SIDMOUTH CYCLING CAMPAIGN

Sidbury Walking and Cycling Scheme

Eastern Route

Summary

Figure 1 – DCC proposal for Eastern Route submitted for Planning Approval in 2015

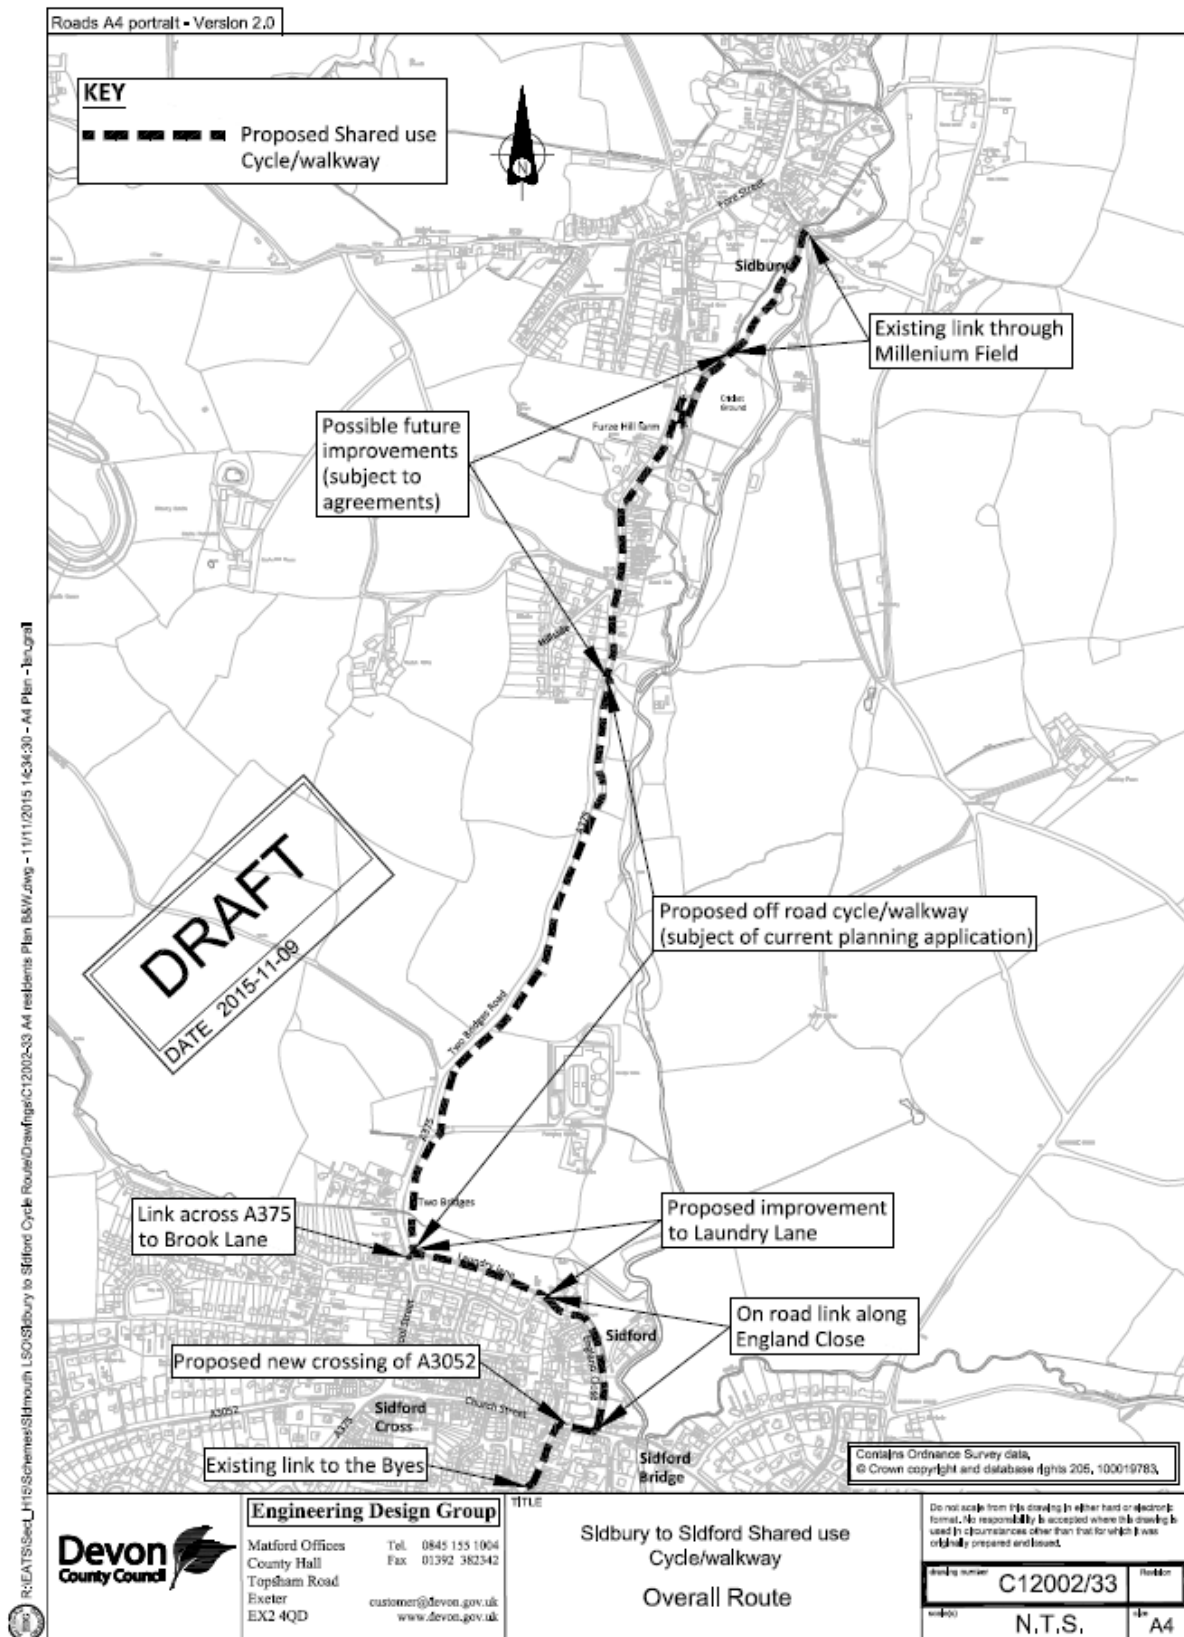
DCC previously submitted a planning application in 2015 for a route on the eastern side of the main road (See Figure 1 below). This application was withdrawn due to a number of constraints.

The main difficulties and constraints with DCC's previous proposal for the eastern route appear to relate to the northern end, where a boardwalk was proposed to bring the path up to the main road. Figures 2 and 3 (below) show a suggested revised alignment that would avoid the need for the boardwalk, by following a lower alignment.

3. Environment: The previous eastern route appears to have been discounted due to the amount of vegetation that would be required to bring it up to the road at its northern end. However, this objection could be overcome by removing this connection and continuing the path at a lower level northwards towards Sidbury (as shown on Figure 3).

Figure 3 – Suggested revised alignment

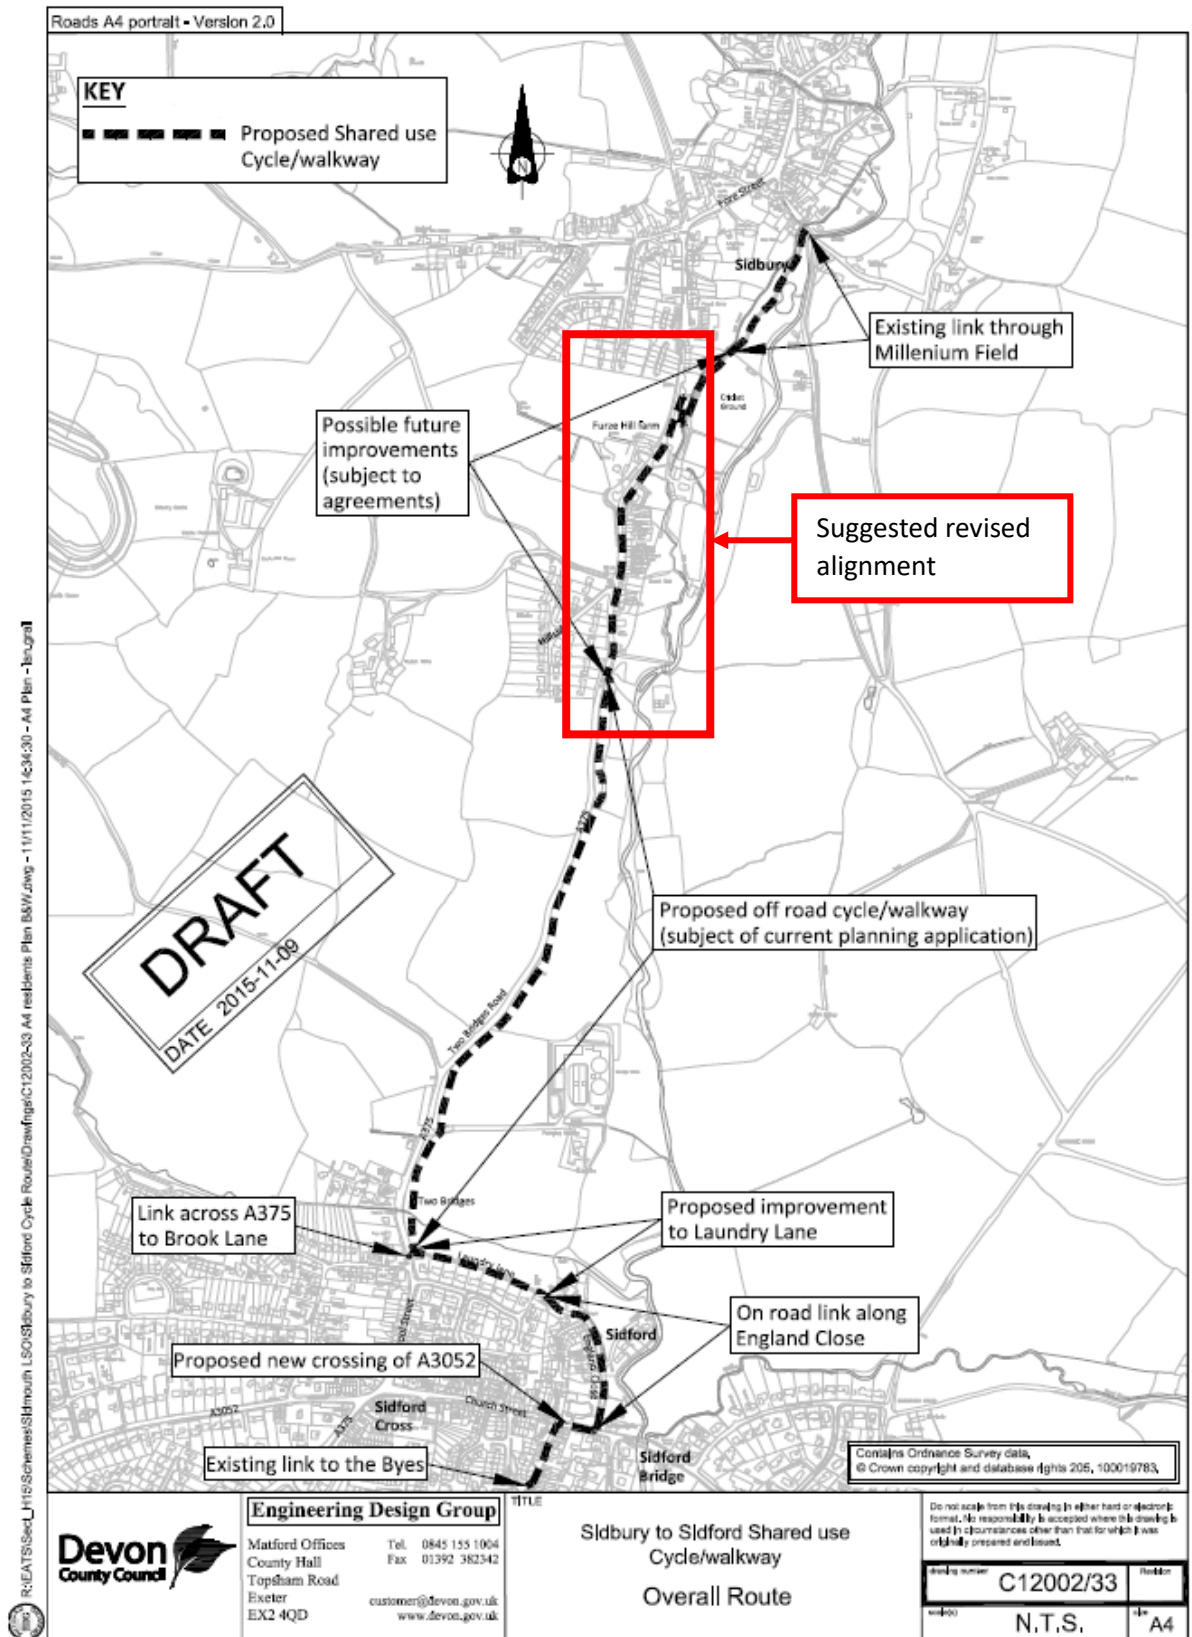
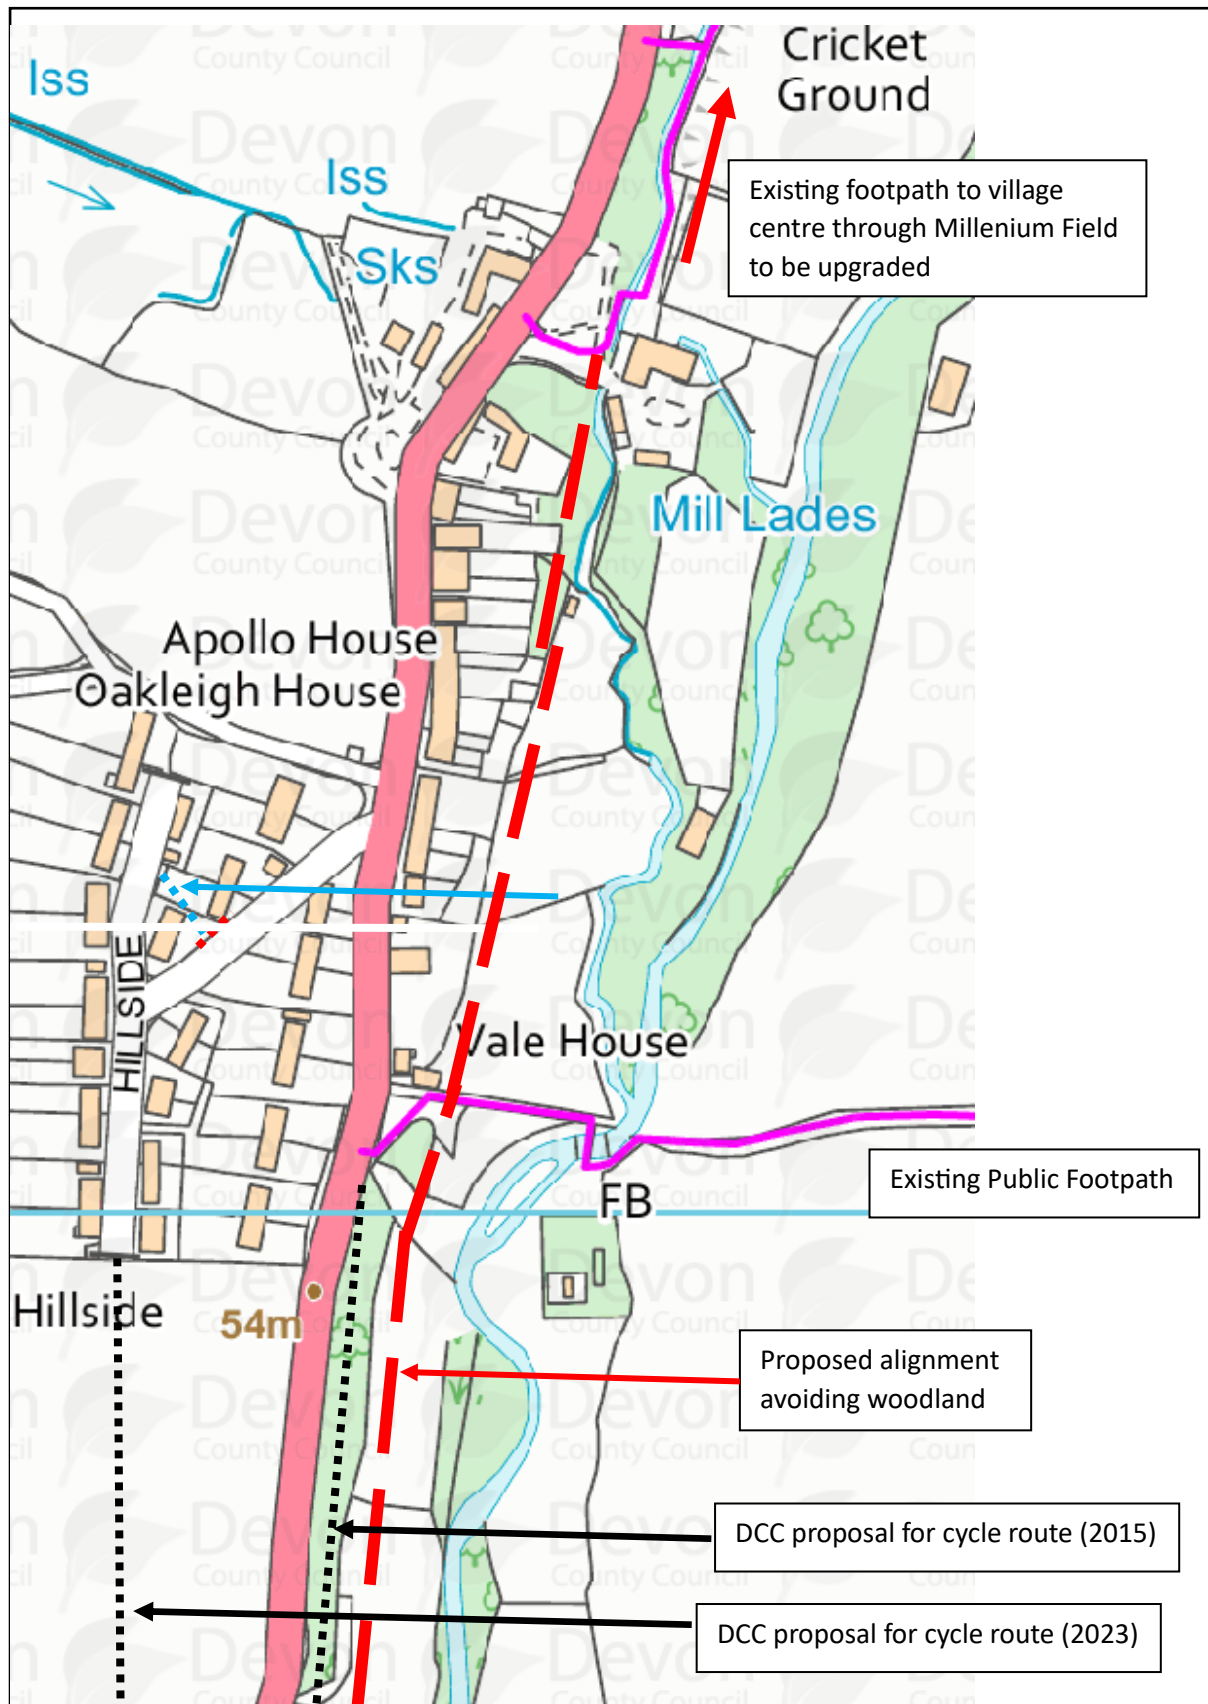
5. Cost: We understand that the western route is being proposed as a cheaper option, although there is no indication that either route has been costed. Our suggested alignment for the eastern route removes the need for an expensive boardwalk, so that it is likely to be of a similar cost to the currently proposed western route.
